COUNCIL SUBMISSION TO REQUEST FOR ADVICE ON EIS – RESIDENTIAL FLAT BUILDING WITH IN-FILL AFFORDABLE HOUSING AT 93 BRIDGE ROAD, WESTMEAD

I refer to the above request to provide advice on the Environmental Impact Statement (and accompanying information) for SSD-80904224 (Residential Flat Building with In-Fill Affordable Housing) at 93 Bridge Road, Westmead.

Appendix 1 – Detailed Comments

Figure 4 Basement Car Park Design

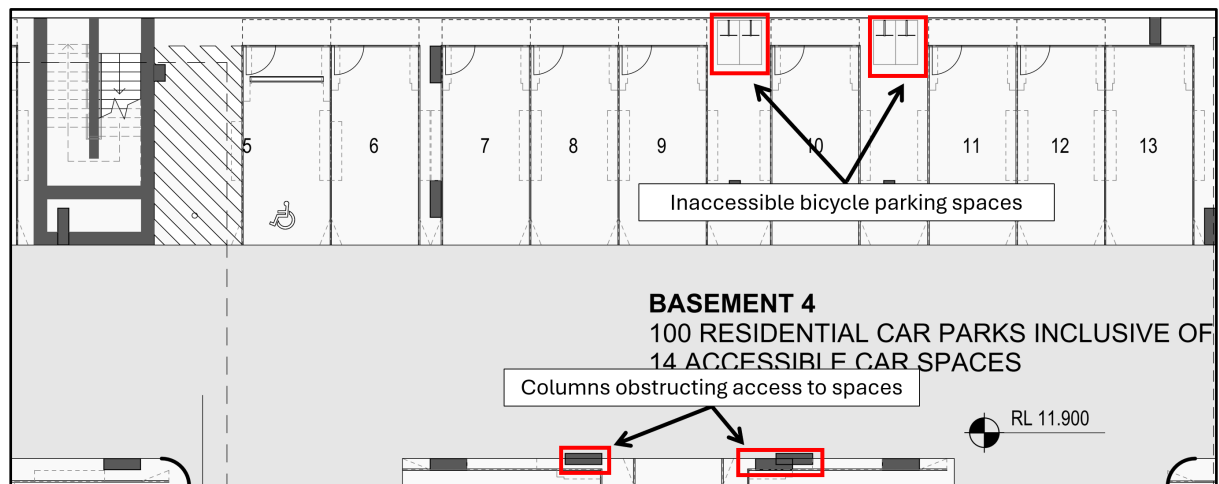
Council notes that parking spaces notated as 7, 8, 9, and 10 on each basement level are adjacent to columns which may obstruct access to these spaces. The columns appear to be reducing the aisle width to between 5.8m and 5.7m. As per the Australian Standards, where

the parking aisle is obstructed on the opposite side to the parking spaces, the aisle width is to be a minimum of 6.1m. Either additional width is to be provided, or swept paths should be provided to demonstrate that access to these spaces will be possible without an excessive number of manoeuvres.

In addition to the above, it is noted that a number of bicycle parking spaces would be inaccessible should there be vehicles parked in adjacent parking spaces. Accordingly, these spaces should be allocated to the same unit that the parking space is allocated (see figure below).

Figure 5 Inconsistencies in ground floor design

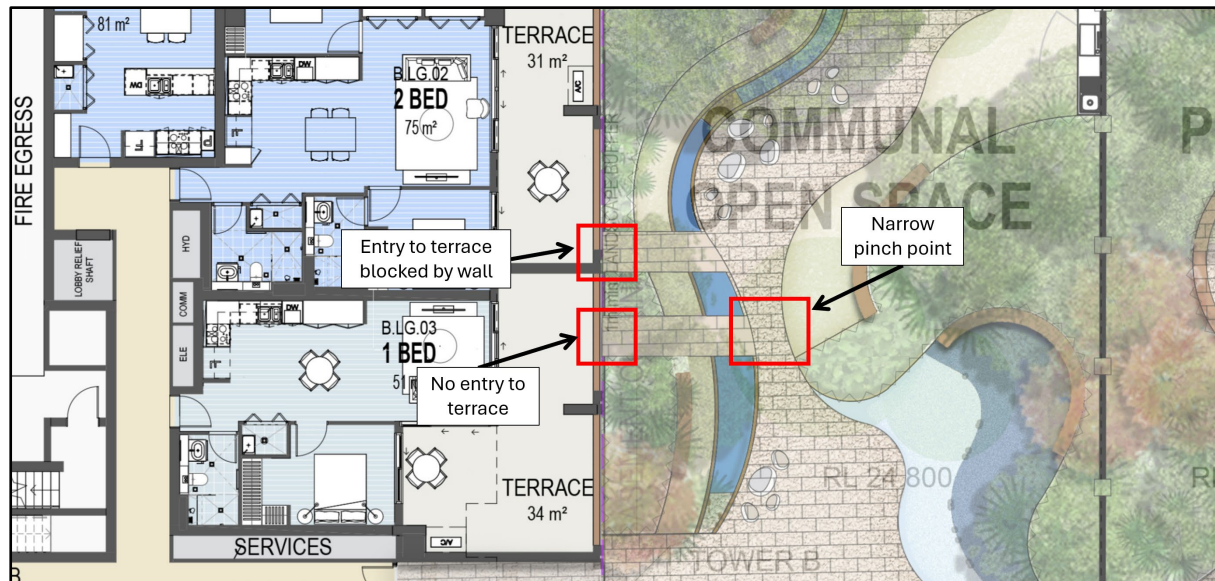
The architectural and landscape plans appear to not be completely coordinated, as there are some paths and entrances into the building from the communal open space shown on the landscape plan that are not shown on the architectural plans on the eastern end. In addition, there are some narrow pinch points in the curved pathways which are not supported, for example there is a 900mm wide pinch point adjacent to a water feature (see figure below). This is recommended to be widened to avoid any potential conflicts along the primary accessible pathway.

It is recommended the communal open spaces are consolidated into a larger, well-designed, easily identified, inviting, usable area to achieve a better design outcome. The consolidation of communal open space(s) would better align with the objectives and intent of Part 3D of the Apartment Design Guide.

Figure 6 Central Communal Open Space Design

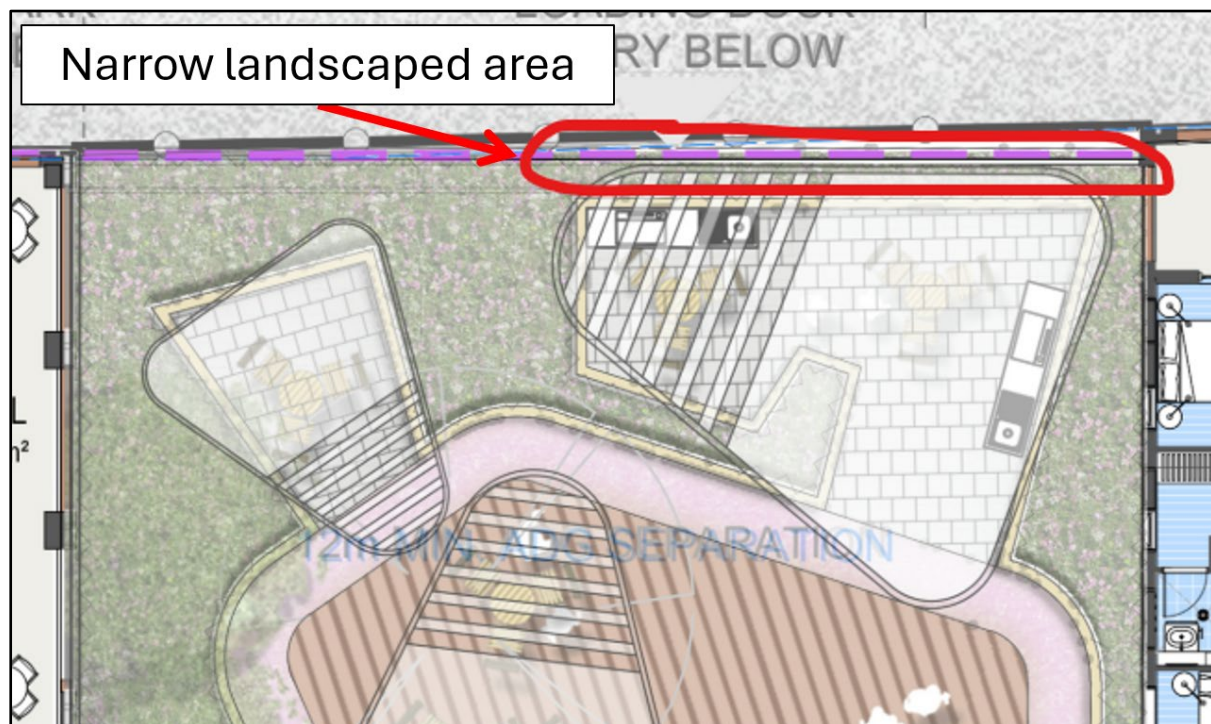
Planting areas in the central communal open space appear to be quite narrow and incapable of supporting plants. In particular, areas adjacent to the BBQ covered facility (above the loading dock entrance) are too narrow to support landscaping.

Council recommends that for communal areas, contiguous (un-isolated) planter boxes for trees be provided.

Figure 7 Unit B.L.G.01 Private Open Space

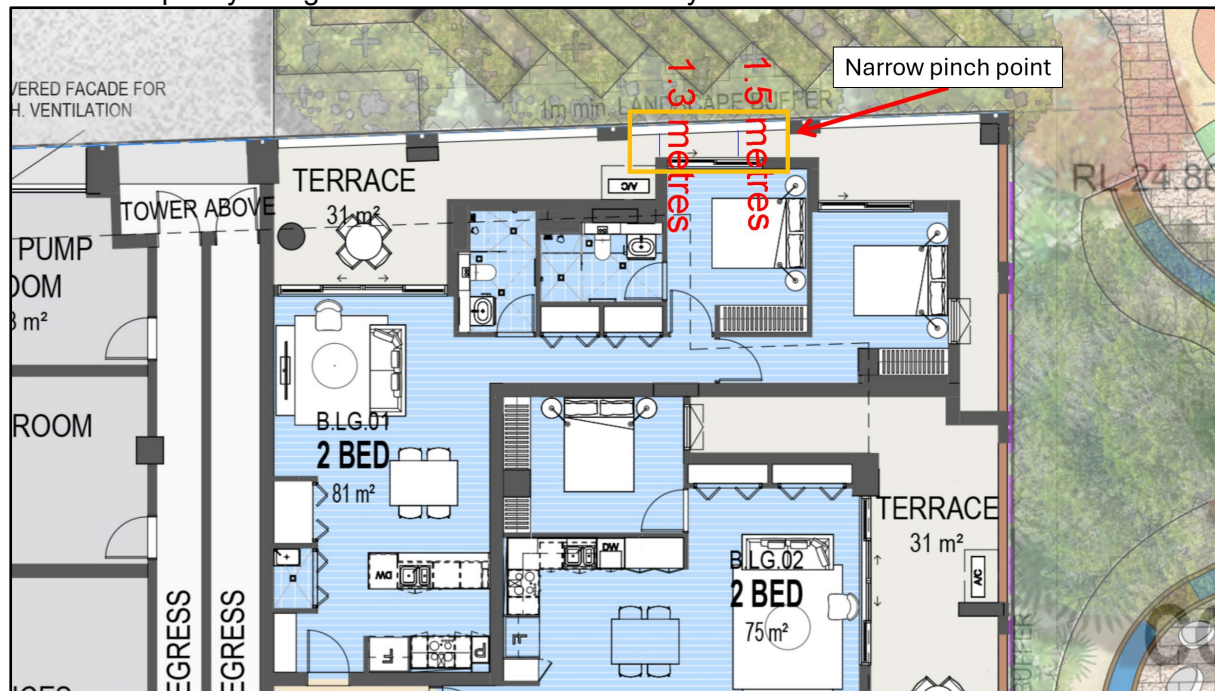
Council notes that the lower ground unit labelled 'B.L.G.01' includes a private open space (terrace) which narrows in width to between 1m-1.5m. The space adjoining the master bedroom is poorly design and would not be usable by residents.

Figure 8 Stormwater Drainage Pipes

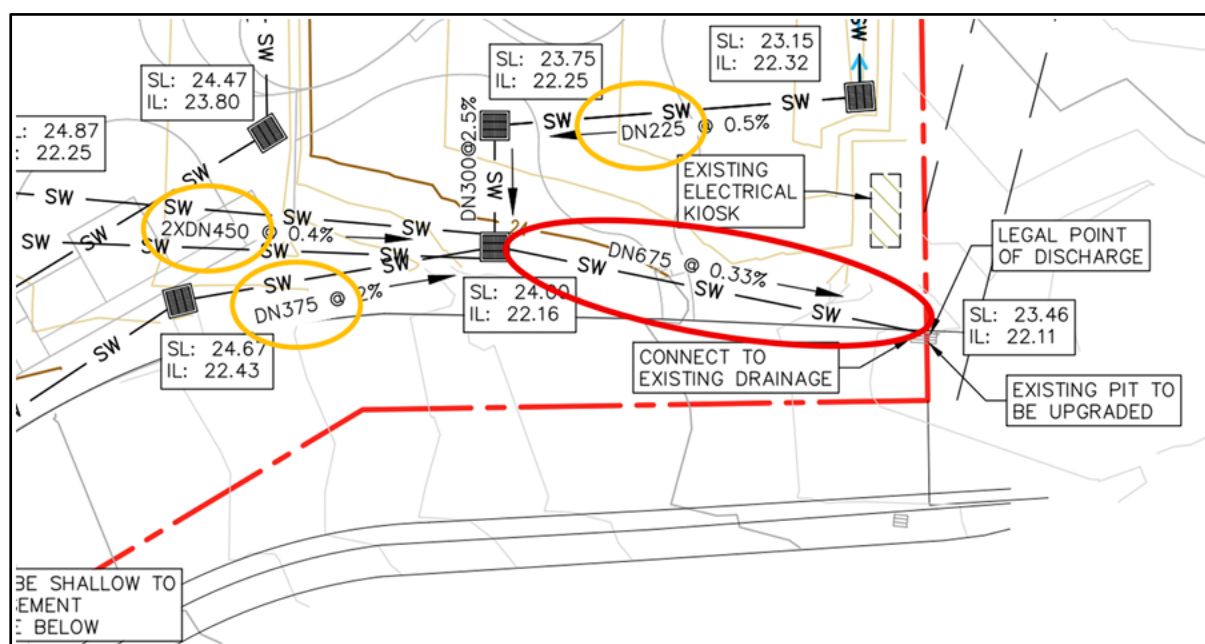
Council notes that the adequacy of the stormwater drainage pipe identified in the below figure (outlined in red) (DN675) has not been confirmed, given that the stormwater inlets are 2 × DN450, DN375, and DN225 (marked with orange circles).

An electronic copy of the DRAINS model must be submitted, along with an electronic copy of the sub-catchment plan and a brief report demonstrating the adequacy and appropriateness of the proposed drainage infrastructure. Appropriate tailwater conditions, wind-driven rain from both towers, and consideration of climate change as a design case must also be incorporated into the drainage model. It is recommended that the current climate change guidelines (ARR 2019, Version 4.2, Book 1, Chapter 6) be adopted.

All drainage infrastructure must be designed to accommodate 5% AEP storms with 50% blockage in sag pits and 20% blockage in on-grade pits, with safe overland flow paths provided for the 1% AEP event under climate change conditions.

The Stormwater Drainage Plan and longitudinal sections must include the horizontal and vertical positions of all existing and proposed service utilities. All longitudinal drainage sections must include the Hydraulic Grade Line (HGL) for both 5% AEP and 1% AEP (with climate change).
